Title:	Proposed Great Wolf Lodge, Chesterton, Bicester	Date Approved:	October 2022
Discipline:	Civils	Author:	Harry Hunter
Note Ref:	2180501-EWP-XX-ZZ-TN-C-0006

Issued for information							
revision:	P2	prepared by:	Harry Hunter BEng (Hons)	checked by:	Paul Davis BEng (Hons) MSc CEng MICE	approved by:	Paul Davis BEng (Hons) MSc CEng MICE
date:	07.10.22	signature:		signature:		signature:

This technical note has been prepared in response to the Lead Local Flood Authority (LLFA) comments on Condition 16 of application number 22/01815/DISC dated 15.09.22.

Title: **General Arrangement of StormTank MPS 59.2 x 13.725 x 3 m**

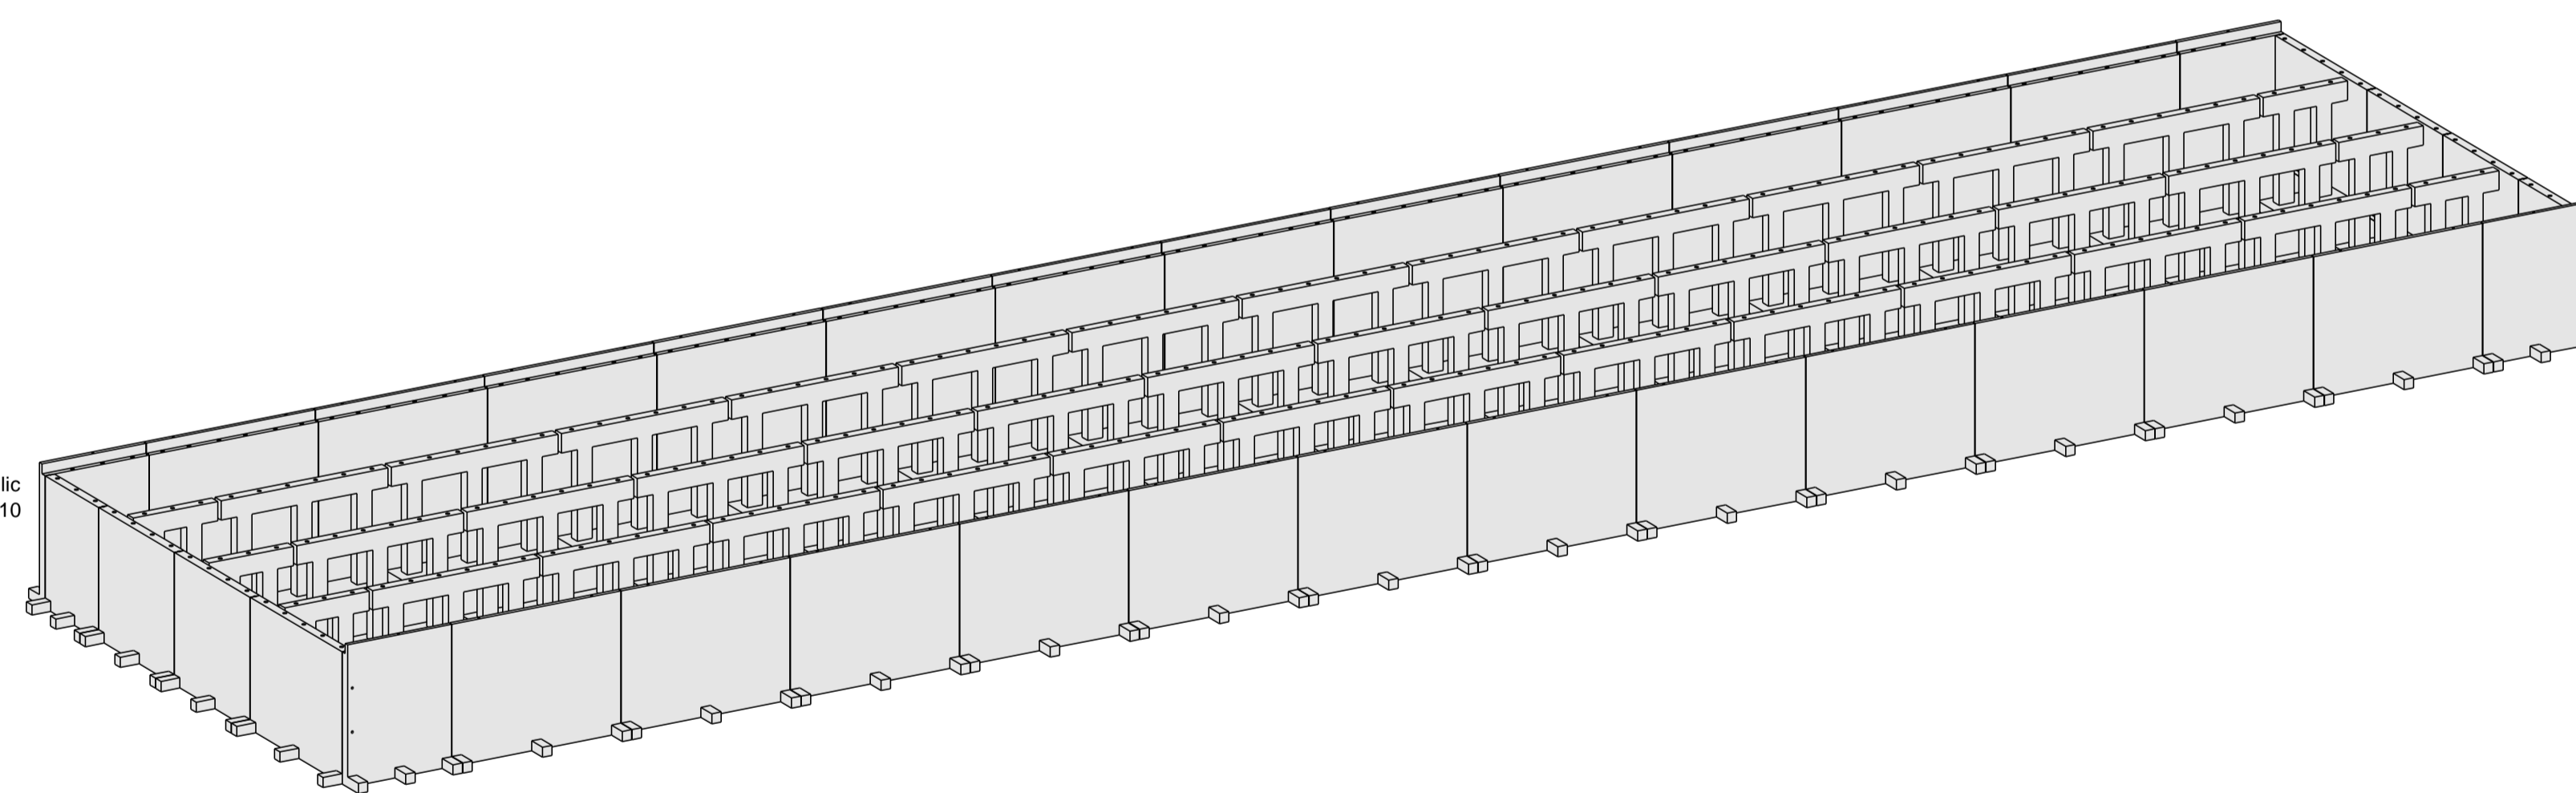
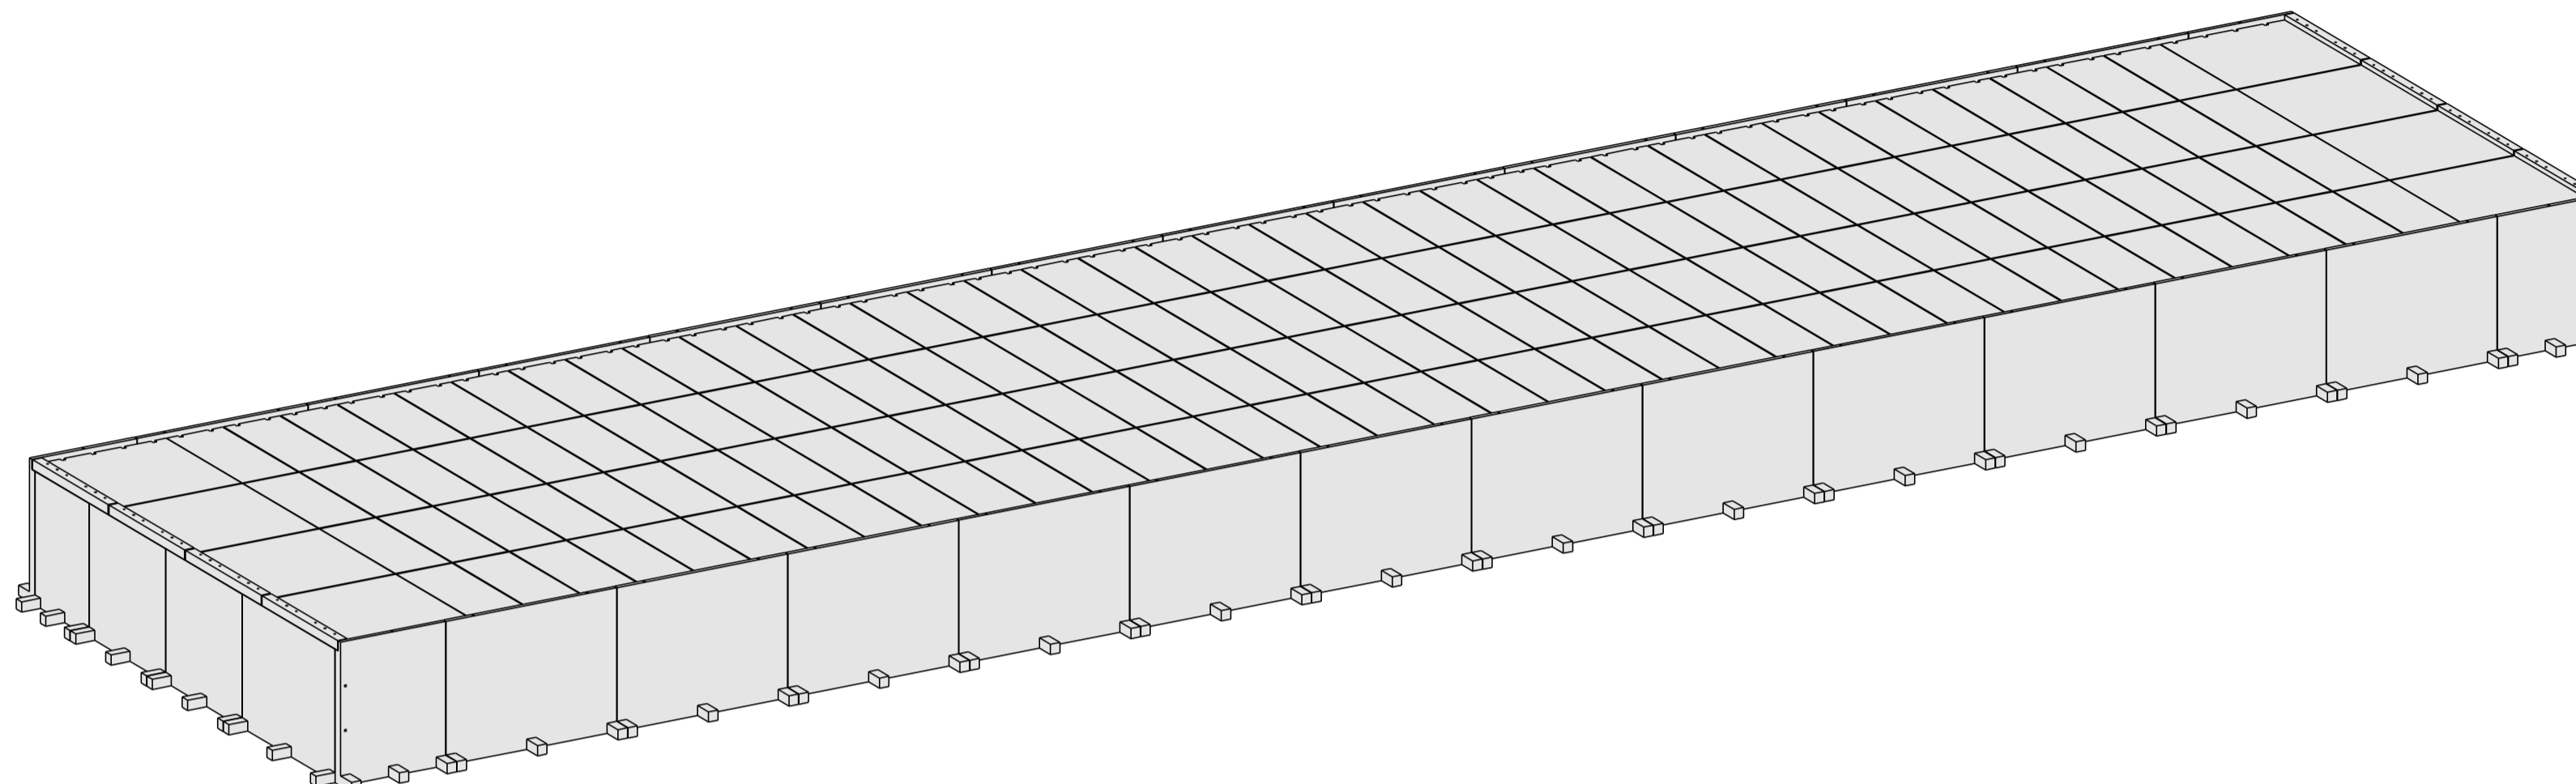
h) Full details of the design and proposed location of the tank and the pipes and the conduits to be installed to convey water to and from the tank, such details to include the materials from which the tank, pipes and conduits are to be made.

It is currently proposed for the attenuation tank to be constructed using Pre-cast reinforced concrete using the FP McCann Stormtank system, along with the conveying pipework to and from the attenuation tank, with SDS providing the smart flow control systems.

FPMcCann have provided detailed drawings for the proposed attenuation tank and are included in **Appendix A** of this document.

Hydro-Brake® Optimum

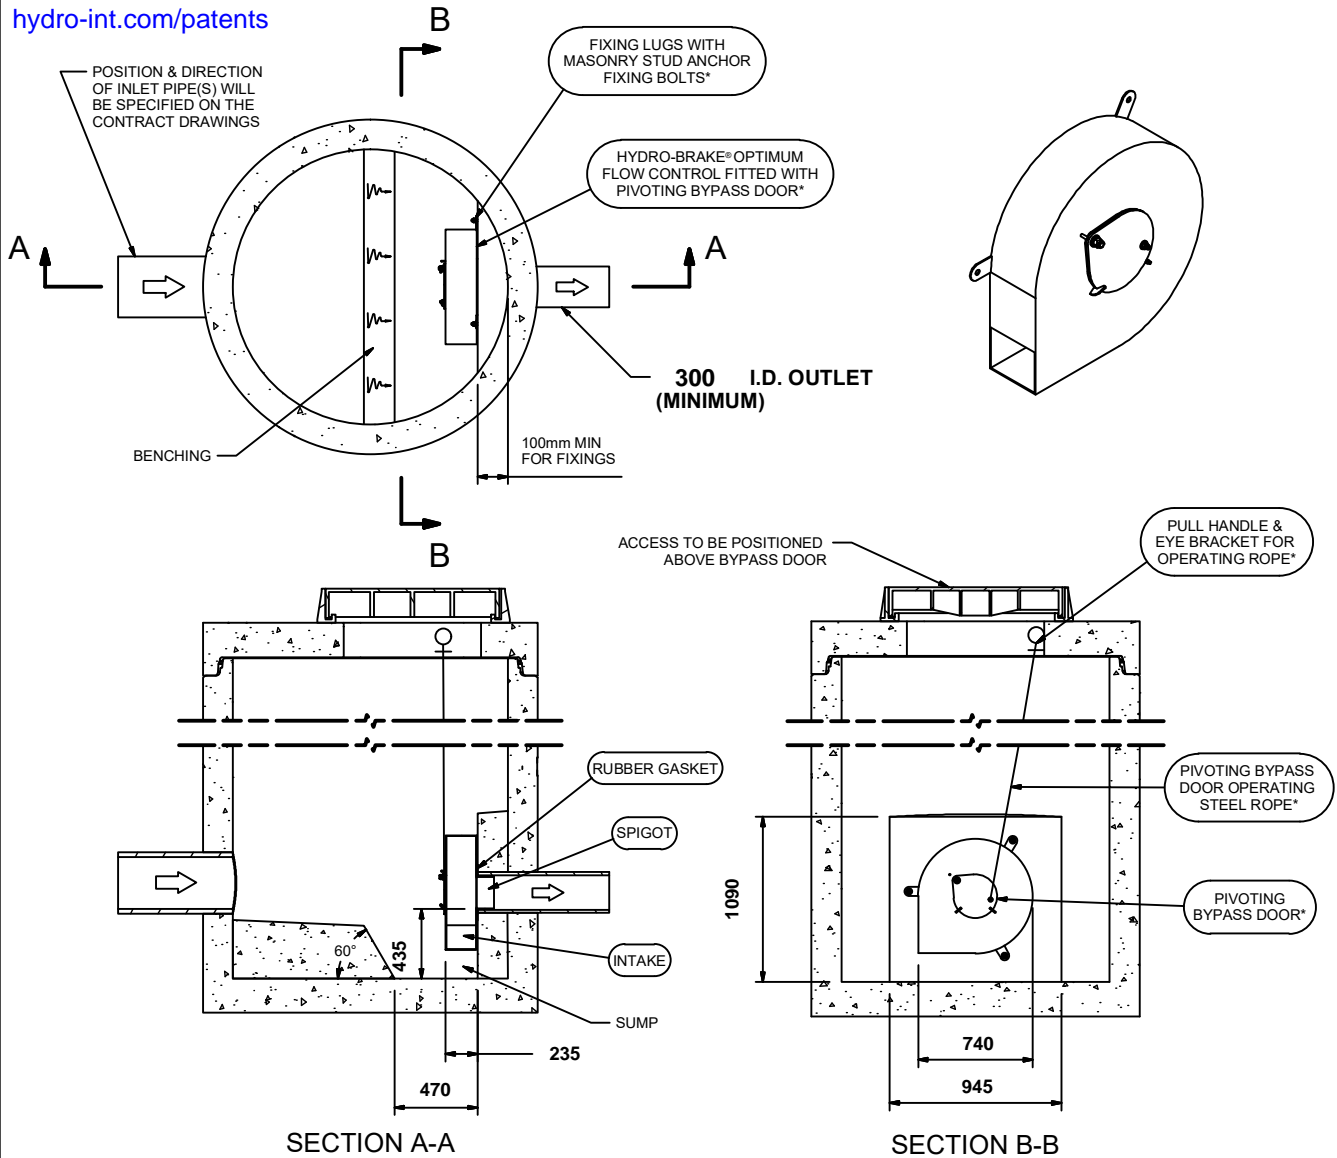
j) full details of the proposed means of operation of the tank, including the control of discharge

The primary method for restricting the offsite discharge is via a HydroBrake vortex flow control chamber as detailed in the Proposed Below Ground Drainage drawings and accompanying Planning Condition 16 Discharge report ref 2180501-EWP-ZZ-XX-RP-C-0004 P1 as previously submitted. Details for the HydroBrake chamber are provided in **Appendix B**.
